**BEAMREACH NETWORKS, INC.
BELL SOUTH CORPORATION
VERIZON WIRELESS, INC.
WORLD COM, INC.**

*Re: Establishment of Rules and Policies for the Satellite
Digital Audio Radio Service in the 2310-2360 MHz Band;
IB Docket No. 95-91*

Response to XM Radio's Supplement to August 29, 2001 White Paper¹

Figure 1 AGC Power Gap Requirement

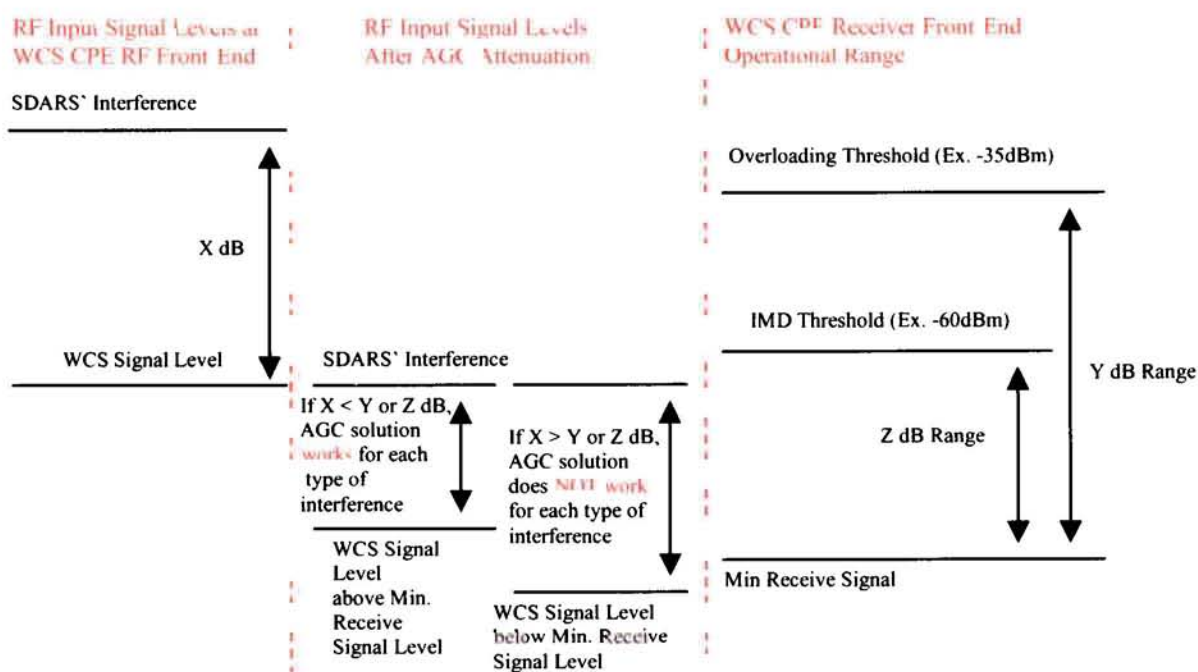
If the difference between the interfering signal level and the desired signal level at the receiver front-end is within the power gap, AGC works for that type of interference. If it is greater than the power gap, AGC does not work. Shown in Figure 1 is a graphic representation of the power gap requirement.

As is obvious from Figure 1, the power levels of the interfering and desired transmitters must be similar if the two transmitters are in the same area. If they are not in the same area, they must be at different power levels and at an appropriate distance from each other as to afford enough path loss to bring the received levels within the power gap range.

Figure 2 Radial Layout For AGC Calculation

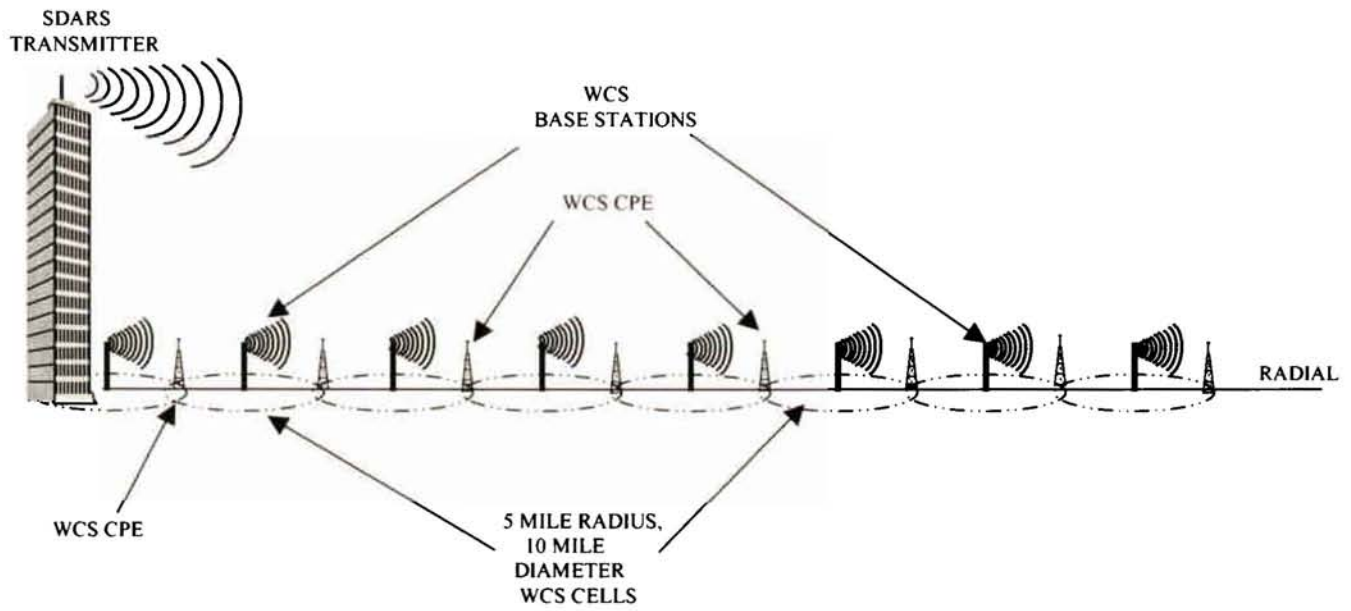
BellSouth Study I: The first study is one similar to that done by XM in its Supplement. The study makes calculations at various points within WCS cells along a radial emanating from the SDARS repeater site to determine if a SDARS interfering signal is above the interference thresholds and if front-end AGC can mitigate the problem. The WCS CPE is always pointed towards the SDARS repeater and no points are selected where antenna discrimination applies. A layout of the SDARS system and the BellSouth WCS cells along the radial is shown in Figure 2. Calculations were made with the following study parameters:

Table 1 shows that XM's AGC proposed solution does not work to reduce overload and intermodulation interference to acceptable levels in all areas of a WCS deployment even when the SDARS transmit power level is 2 kW.

Figure 3
RF Coverage from WCS Base Station at 2W

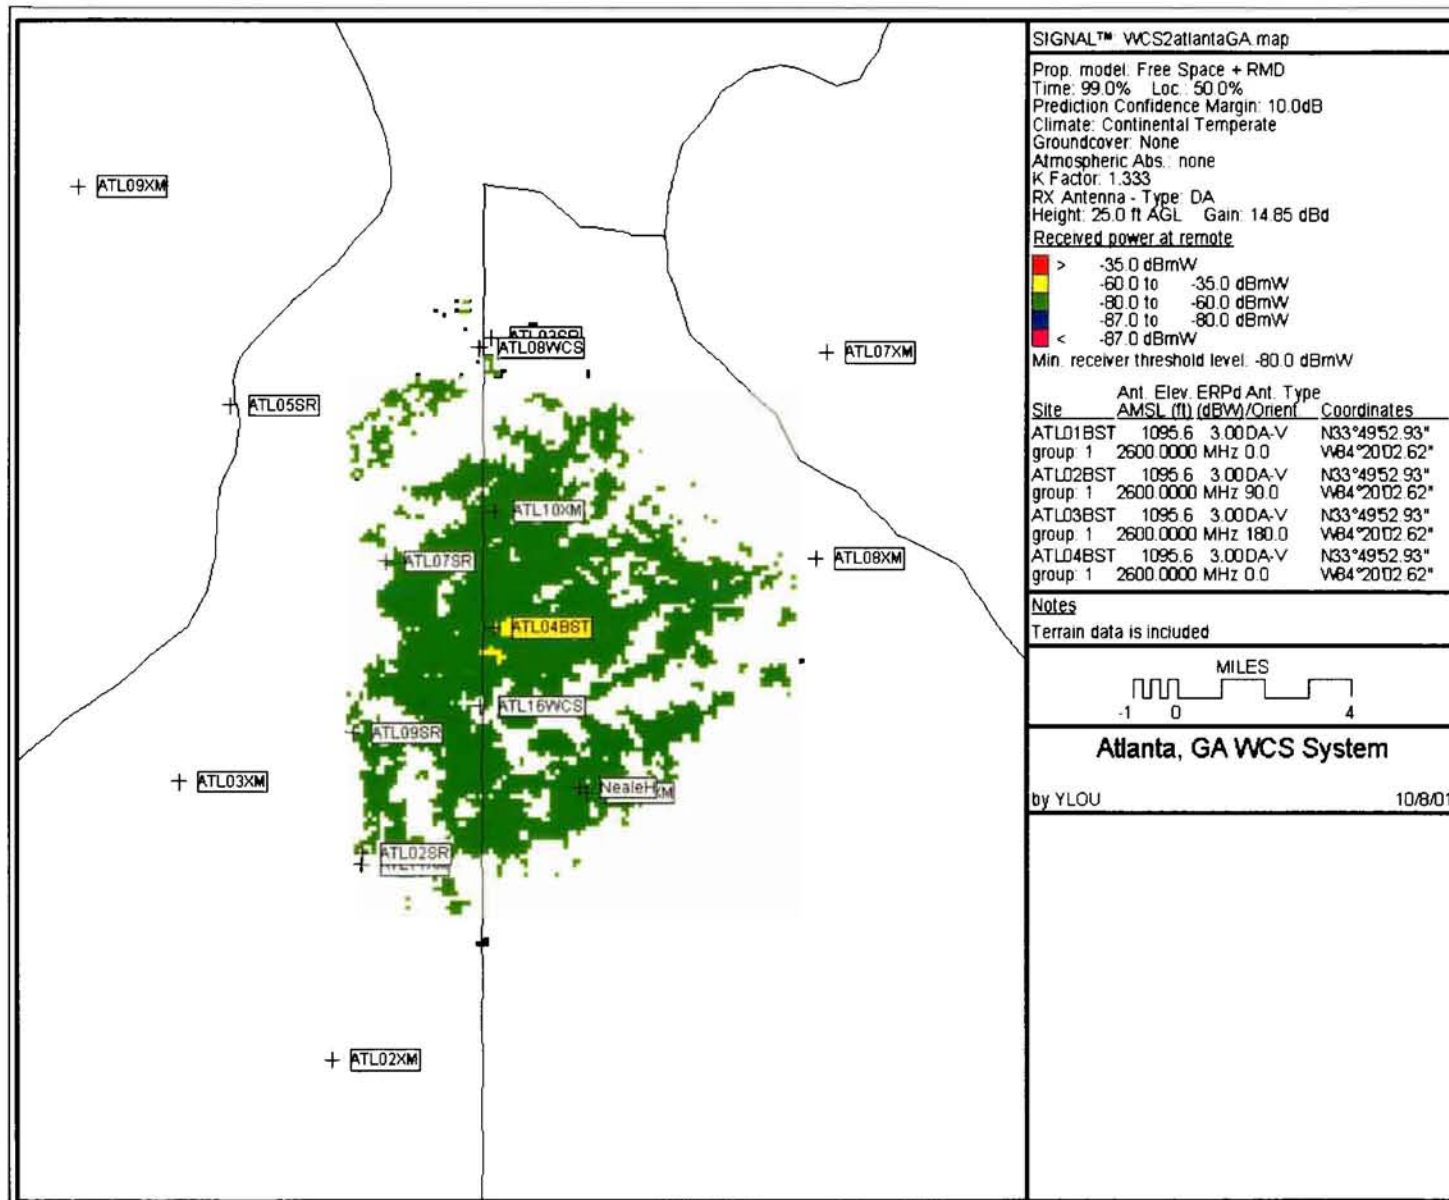
Figure 3 shows the RF coverage area of WCS base station ATL04BST that is located 2 miles from a non-transmitting SDARS site collocated with WCS base station ATL16WCS. The usable RF coverage includes the areas shown by the colors green and yellow. RF coverage varies from 3 to 6 miles.

Figure 4
SDARS (at 40KW) Interference to WCS System

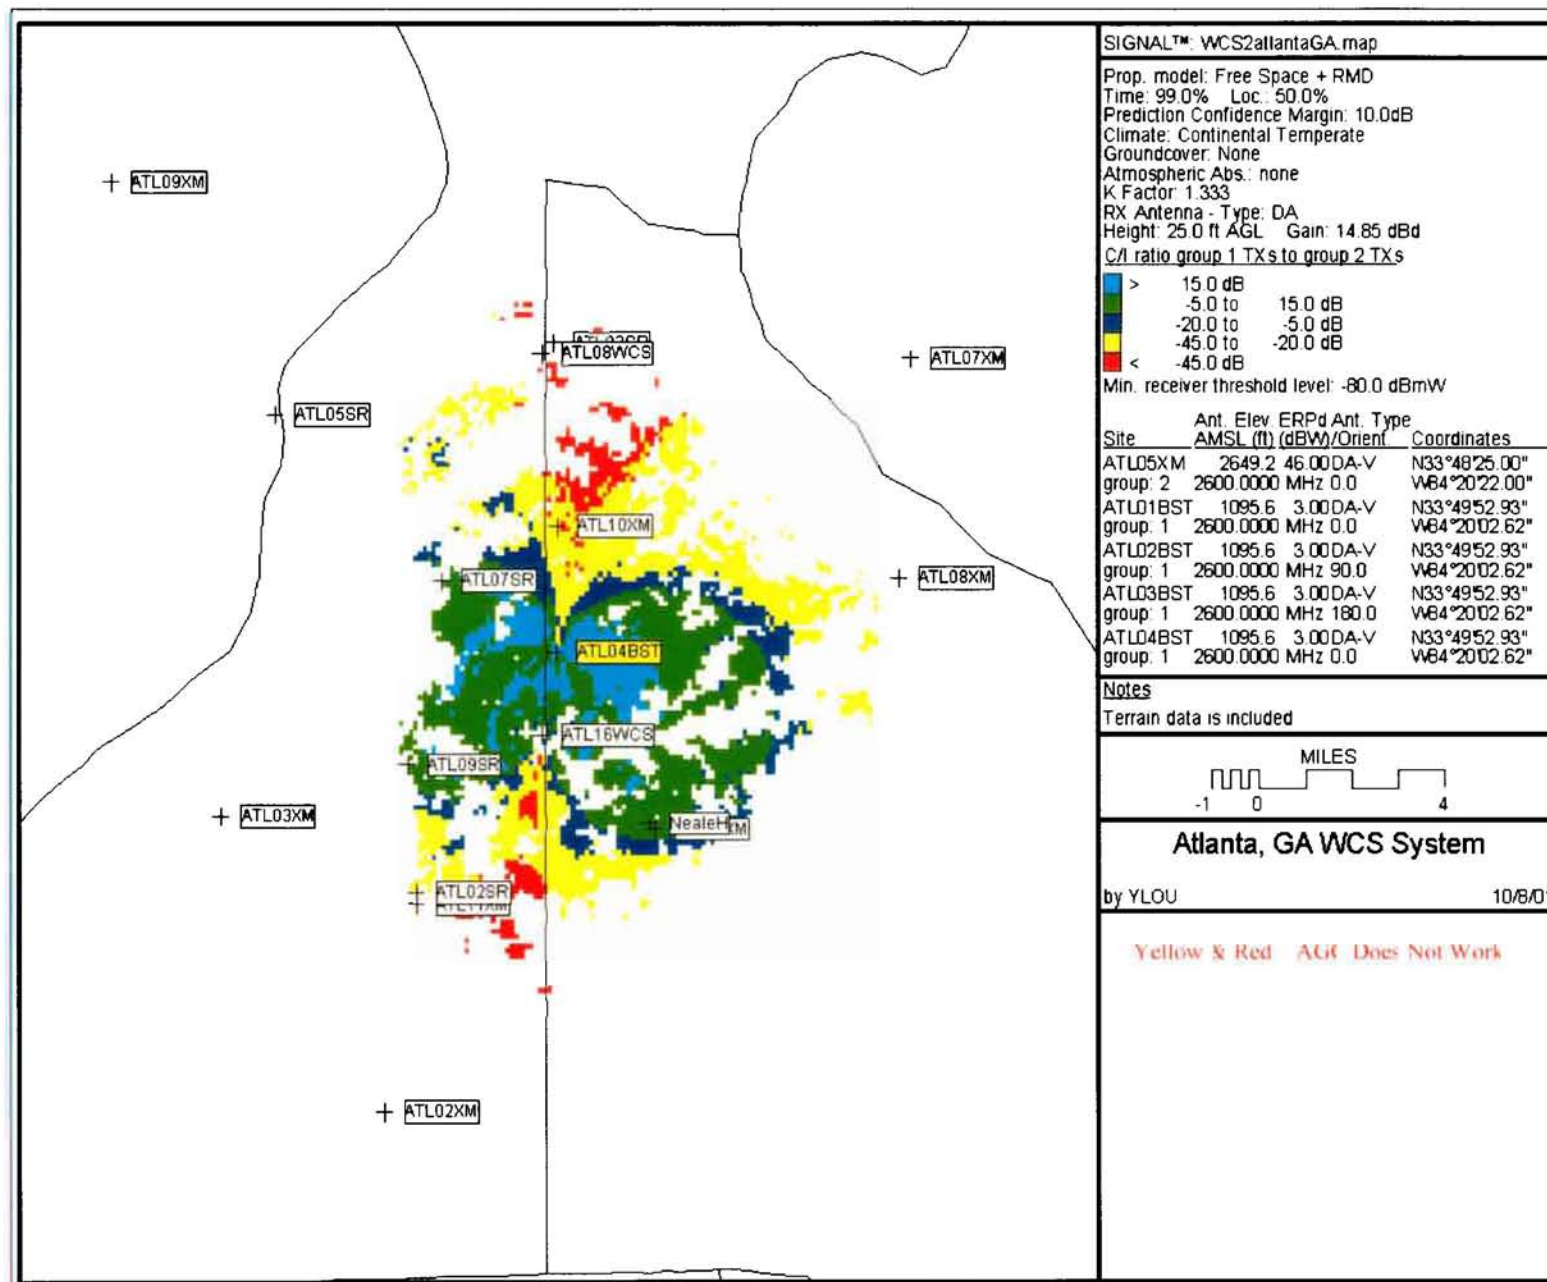
In Figure 4 the SDARS transmitter collocated with WCS base station ATL16WCS is turned on with an EIRP of 40 kW. This simulation again looks at the RF coverage area of WCS base station ATL04BST. The WCS CPE in the WCS cell coverage area is equipped with RF front-end AGC. The new WCS cell coverage is shown by the colors blue, green and bluish green. These colors represent receive levels with a power gap of 20 dB or less.

- The areas colored by yellow and red are the areas where AGC does not work for intermodulation interference.
- The area colored in red is the area where AGC does not work for overload interference.

Because of the inability of the AGC to mitigate the interference, the WCS cell radius has been reduced to 0 to 4 miles with *a loss in area covered of 41%*.

Figure 5
SDARS Repeater at 7.3KW (Original Design) Interference to WCS System

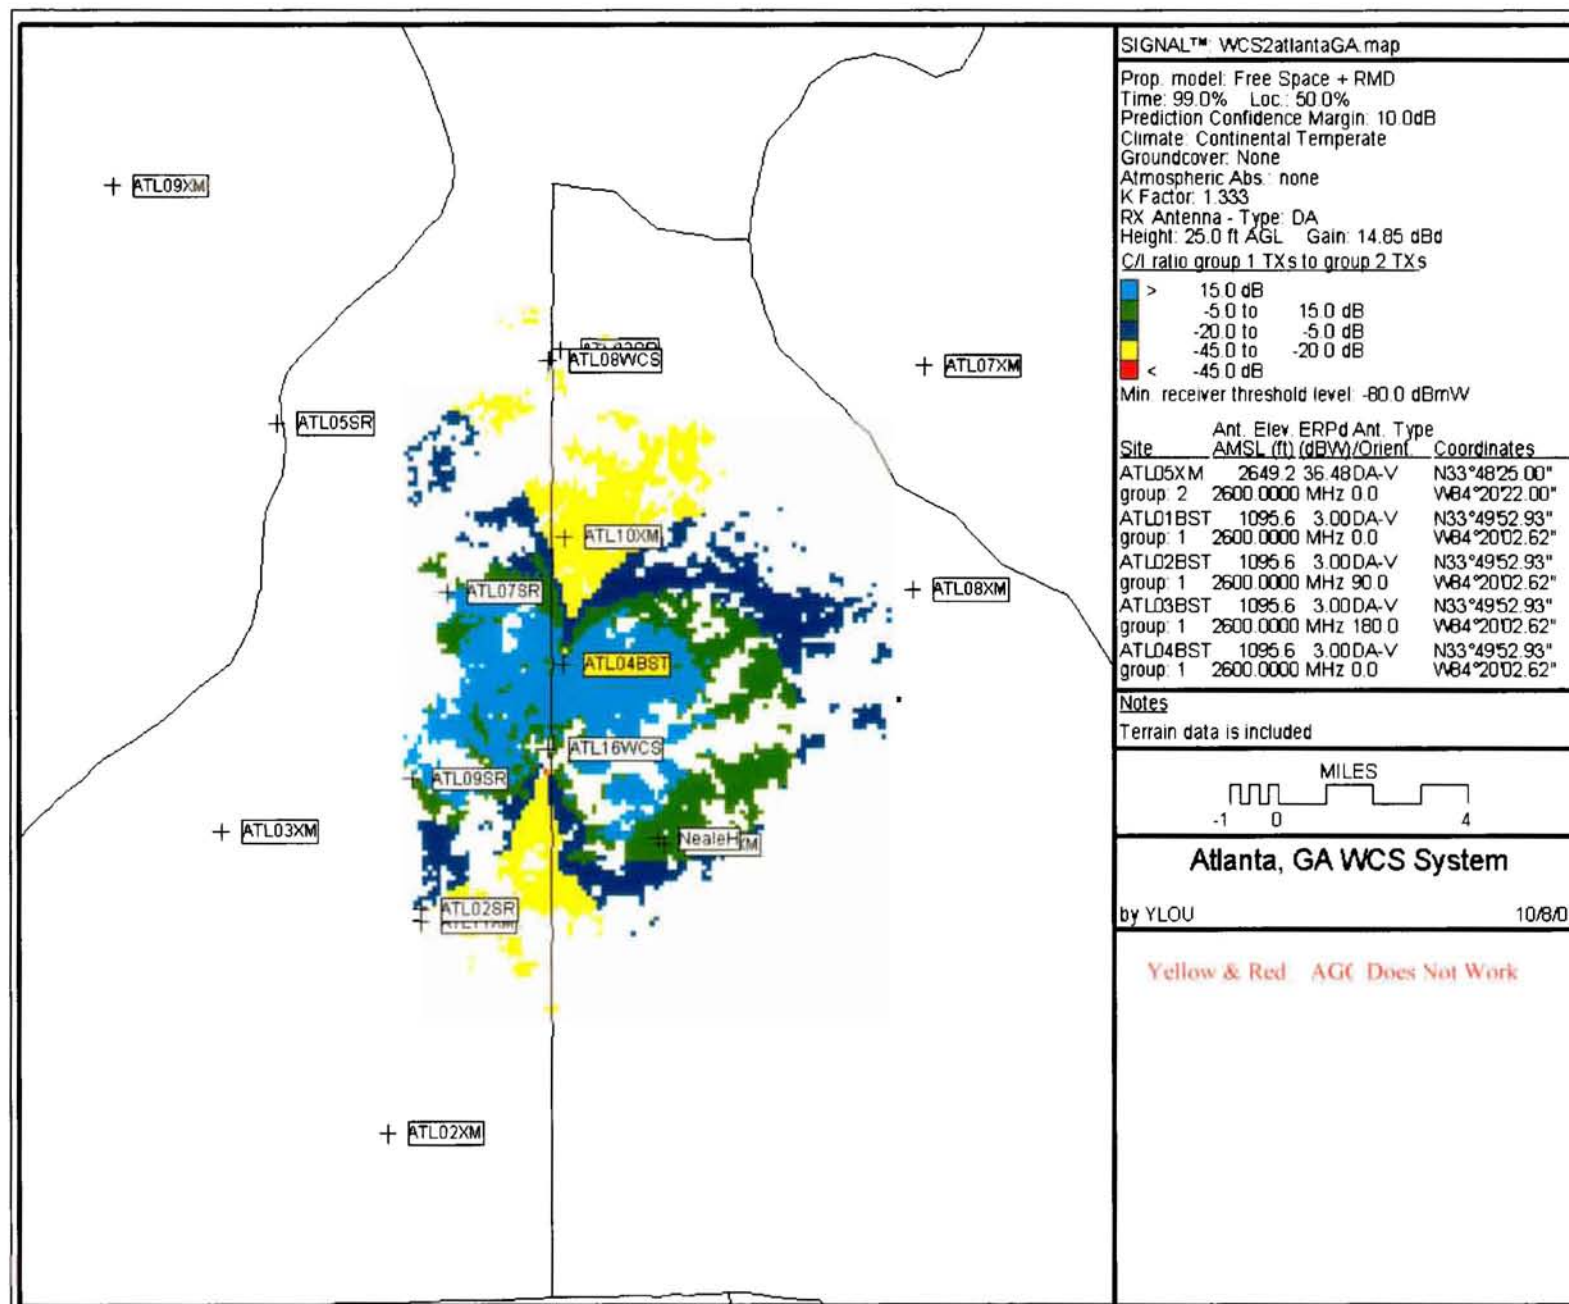
In Figure 5 the SDARS transmitter collocated with WCS base station ATL16WCS is turned on with an EIRP of 7.3 kW. This SDARS EIRP is the level stated in the XM STA application. This simulation again looks at the RF coverage area of WCS base station ATL04BST.

The WCS CPE in the WCS cell coverage area is equipped with RF front-end AGC. The WCS cell coverage at this SDARS EIRP is shown by the colors blue, green and bluish green. These colors represent receive levels with a power gap of 20 dB or less.

Because of the inability of the AGC to mitigate the interference, the WCS cell radius has been reduced to 0.5 to 5 miles with *a loss in area covered of 22%*.

Figure 6
SDARS Repeater at 2KW Interference to WCS System

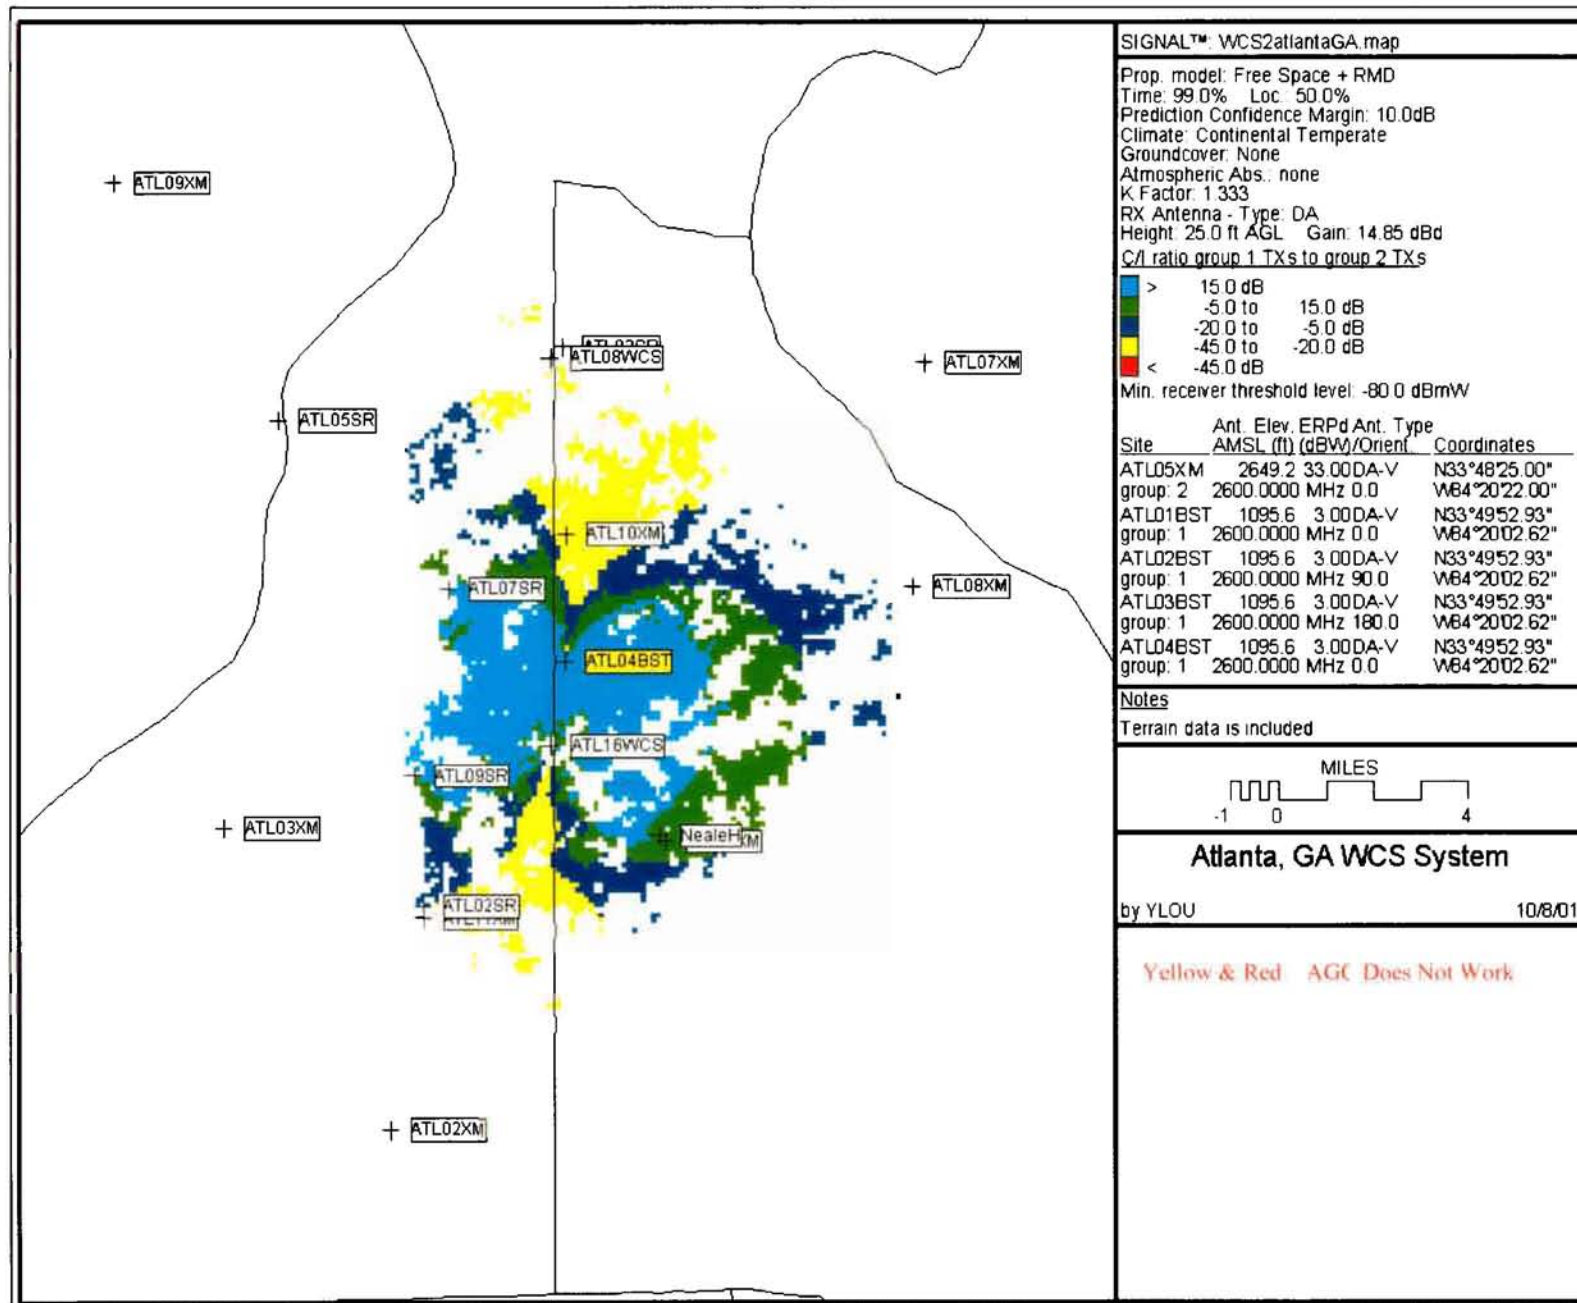
In Figure 6 the SDARS transmitter collocated with WCS base station ATL16WCS is turned on with an EIRP of 2 kW. This simulation again looks at the RF coverage area of WCS base station ATL04BST. The

WCS CPE in the WCS cell coverage area is equipped with RF front-end AGC. The WCS cell coverage at this SDARS EIRP is shown by the colors blue, green and bluish green. These colors represent receive levels with a power gap of 20 dB or less.

Because of the inability of the AGC to mitigate the interference, the WCS cell radius has been reduced to 1.2 to 6 miles with *a loss in area covered of 8%*.
